# UNITED STATES PATENT AND TRADEMARK OFFICE

APPLICATION NO.	FILING DATE	FIRST NAMED INVENTOR	ATTORNEY DOCKET NO.	CONFIRMATION NO.
09/336,207	06/18/1999	ROBERT G. MCCrackEN	8594560/9702	7367

**Office Action Summary**

***Claim Rejections - 35 USC § 103***

EXAMINER'S ATTACHMENT

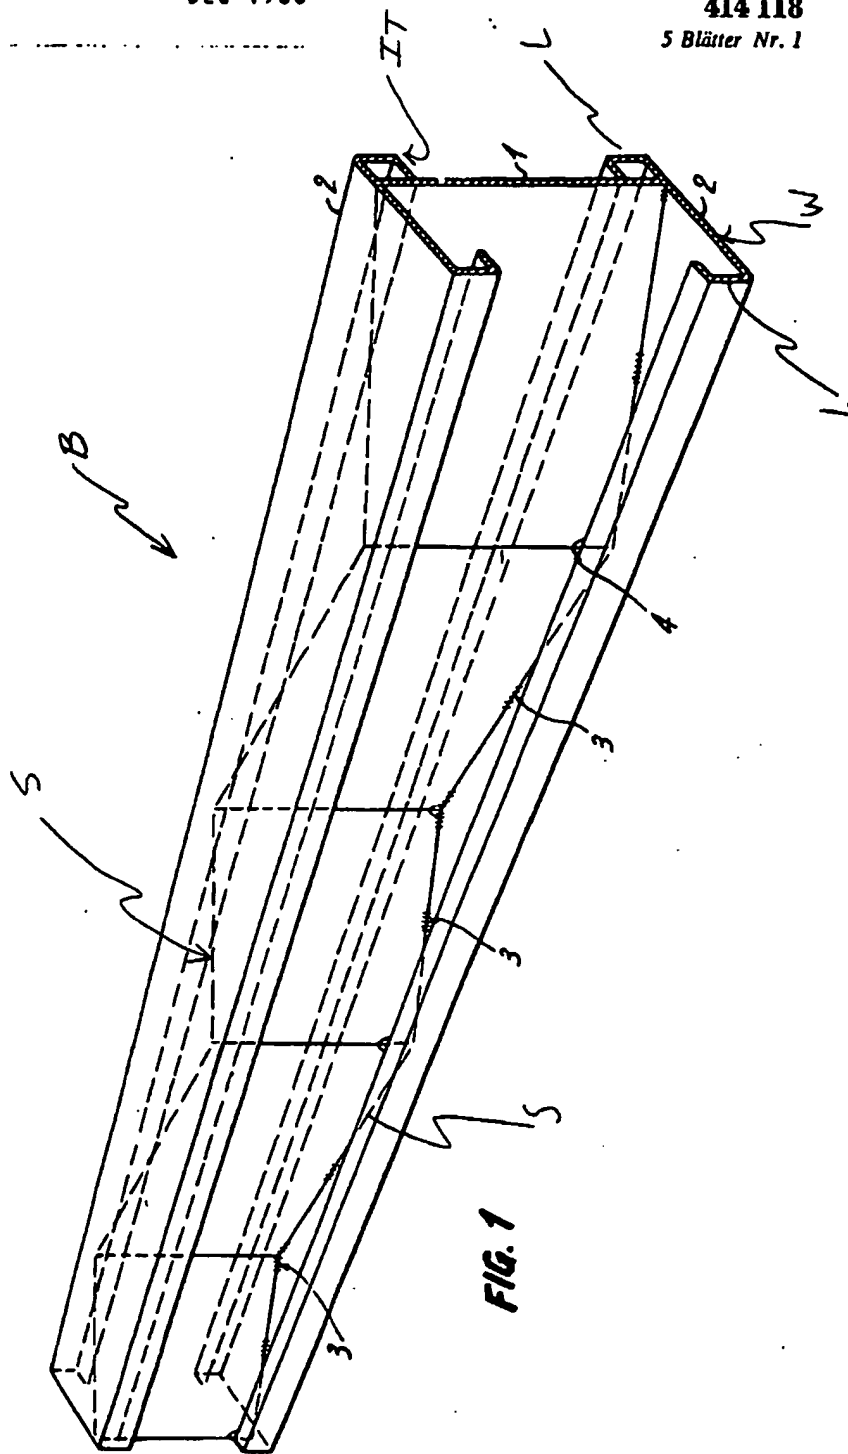
Regarding to claims 8 and 9, the web member (W) is secured to the central web section (20) of the flanges (2) by welds (3), and the protrusions (4) are also secured to the leg sections (L) and in-turned portions (1T) by welds (3).

In further regards to claim 11, the flanges (2) are C-shaped and leg sections (2) include in-turned portions (IT), (See also the marked-up attachment).
